Access Compliance Report

Public Rights-of-Way

(Curb Ramps)

Intersection ID: 18800	Main Street: PARK_RD	Cross Street: SENECA_PL	Location: SE
ADA ID: 054D8C4B9E05	Ramp Type: BlendTrans2	Initial Pass/Fail: Fail	Overall Compliance: No
Codes/Mitigation Info/Possible Solution		Field Measurements/Component Compliance	
Severity Score: 21.25

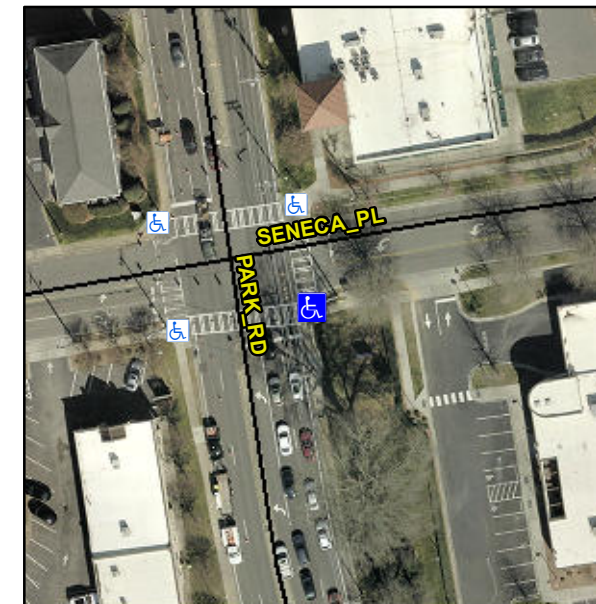
Not Found, R304.5.1, R304.5.3

Compliance	Description	Data	Compliance	Description	Data
N/A	Ramp Length (in)	92.0	Yes	BlendTrans Slope (%)	4.7
No	Ramp Width (in)	45.0	No	BlendTrans XSlope (%)	6.2
N/A	Flare Type LT	N/A	N/A	Flare Type RT	N/A
N/A	Flare Slope LT (%)	N/A	N/A	Flare Slope RT (%)	N/A
N/A	Flare Traversable LT?	N/A	N/A	Flare Traversable RT?	N/A
N/A	Landing Length (in)	N/A	N/A	DWS Provided?	N/A
N/A	Landing Width (in)	N/A	N/A	DWS Contrast?	N/A
N/A	Landing Slope (%)	N/A	N/A	DWS Length (in)	N/A
N/A	Landing X Slope (%)	N/A	N/A	DWS Full Width?	N/A
N/A	Landing Curb? (Y/N)	N/A	N/A	DWS Offset (in)	N/A
N/A	Shared Landing?	N/A			
N/A	Gutter Ponding?	N/A	N/A	Gutter Slope (%)	N/A
N/A	Gutter Lip Ht (in)	N/A	N/A	Gutter X Slope (%)	N/A
N/A	Painted X Walk1?	Yes	N/A	Painted X Walk2?	Yes
	X Walk 1 Direction	To N		X Walk 2 Direction	To W
	X Walk 1 Width (in)	110.0		X Walk 2 Width (in)	120.0
	X Walk 1 Slope (%)	2.3		X Walk 2 Slope (%)	0.2
	X Walk 1 X Slope (%)	3.7		X Walk 2 X Slope (%)	3.0

N/A	Ramp inside XWalk1?	Yes	N/A	Ramp inside XWalk2?	Yes
	Road Slope (%)	3.9		Clear Space?	N/A
	Road X Slope (%)	2.0	N/A	Clear Space to XWalk (in)	N/A
N/A	Any Obstructions?	N/A	N/A	Storm Grate/Utility Hazard?	N/A
	Obstruction Type			Storm Grate/Utility Type	
		N/A			N/A
		Yes		Surface Condition? (G/P)	Good
		No		Curb Slope (%)	14.6

Remove & Replace Curb Ramp With Two New Directional Ramps or Equivalent.
